Z-70  
(2016)

**PETITION NO:** Z-70

# Z-70-2016 GIS

# Summary of Intent for Rezoning\*

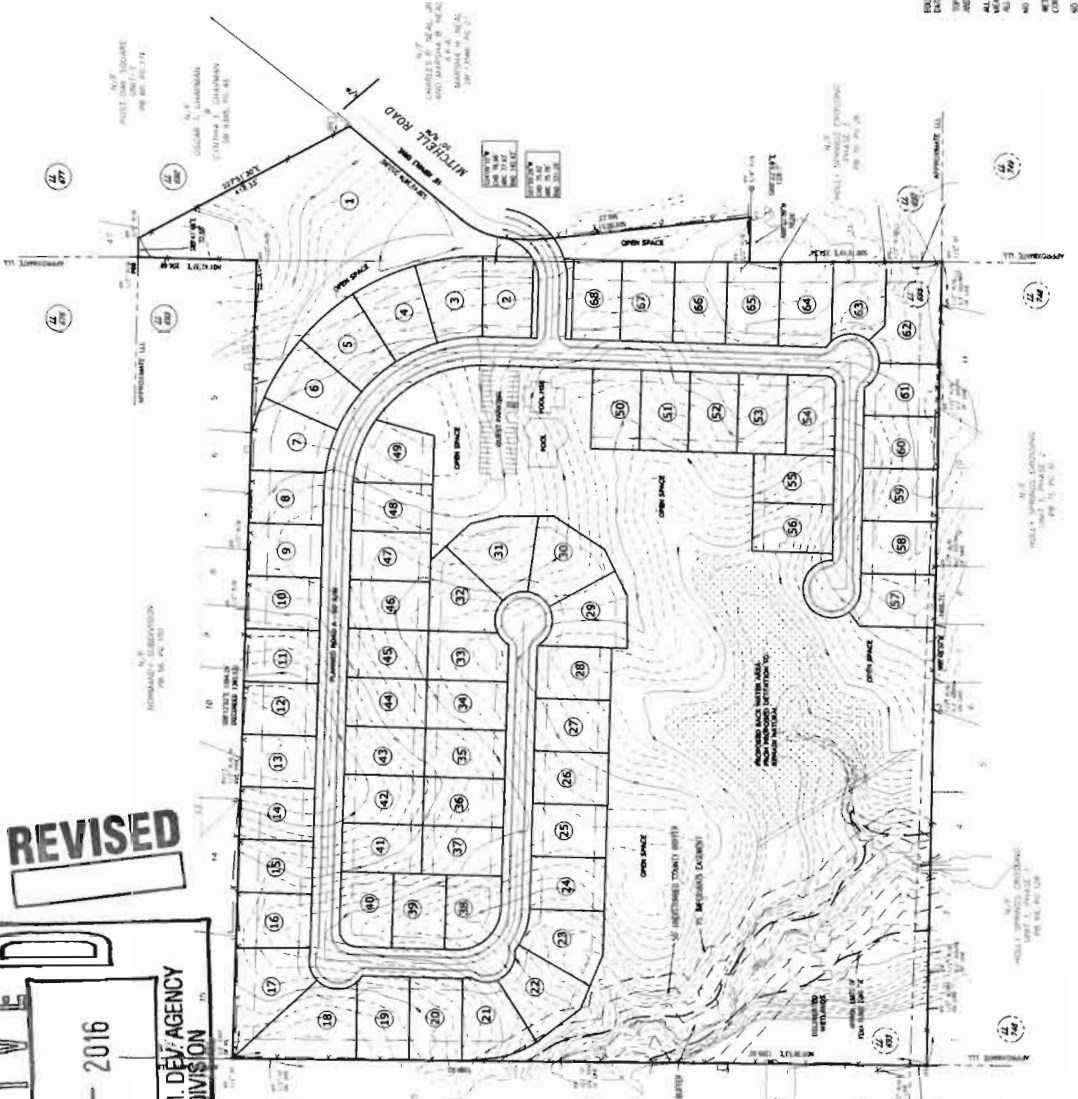
- Guest Parking be implemented to facilitate clear roadways for emergency vehicle response

Development as proposed per revised site plan received on 07/01/16 meets the technical requirements of the OSC ordinance and the minimum required percentage of open space that allows a base density no more than 1.75 units per acre for an R-20 OSC. To further enhance this proposal the following comments and recommendations should be met.

1. Provide north arrow on site plan.
2. If walking or bike trails are proposed throughout open space please add them to site plan and note that they will be constructed of porous materials.
3. Incorporate larger lots adjacent to existing neighborhoods with smaller lots designed to the interior. Specifically, lots 8 through 21 and 57 through 65.
4. Must have Cobb Department of Transportation approved lighting plan in if outdoor lighting (except individual residential lots) is proposed
5. A Conservation Easement must be recorded in the mandatory subdivision covenants and with Cobb Superior Court, thereby protecting the "Open Space" from development in perpetuity as owned by the mandatory Home Owners Association. Conservation Easement application must be submitted to the Planning Division before final plat approval.

6. Provide stipulation letter
7. For all lots contiguous to open space staff recommends including a deed during sale of homes so that future lot owners are aware that commonly owned open space exists adjacent to their property and cannot be built on.
8. As another form of privacy barrier staff recommends installing fence (split rail or any fencing compatible with architecture/landscaping/design of development) to the rear of lots that are adjacent to open space
9. Provide lot size listing on site plan along with average lot size and minimum lot size.
10. Provide architectural renderings and description of the façade treatments that will be used on the proposed housing units.

- Provide comprehensive hydrology/stormwater controls to include development of out parcels.
- Submit all proposed site improvements to Plan Review.
- Any **spring activity** uncovered must be addressed by a qualified geotechnical engineer (PE).
- Structural fill \_\_\_\_\_ must be placed under the direction of a qualified registered Georgia geotechnical engineer (PE).
- Existing facility.
- Project must comply with the Water Quality requirements of the CWA-NPDES-NPS Permit and County Water Quality Ordinance.
- Water Quality/Quantity contributions of the existing lake/pond on site must be continued as baseline conditions into proposed project.
- Calculate and provide % impervious of project site.
- Revisit design; reduce pavement area to reduce runoff and pollution.

- No Stormwater controls shown \_\_\_\_\_
- Copy of survey is not current – Additional comments may be forthcoming when current site conditions are exposed.
- No site improvements showing on exhibit.

1. Site plan received July 1, 2016, with the District Commissioner approving minor modifications;
2. Fire Department comments and recommendations;
3. Planning Division comments and recommendations;
4. Water and Sewer Division comments and recommendations;
5. Stormwater Management Division comments and recommendations; and
6. Department of Transportation comments and recommendations.
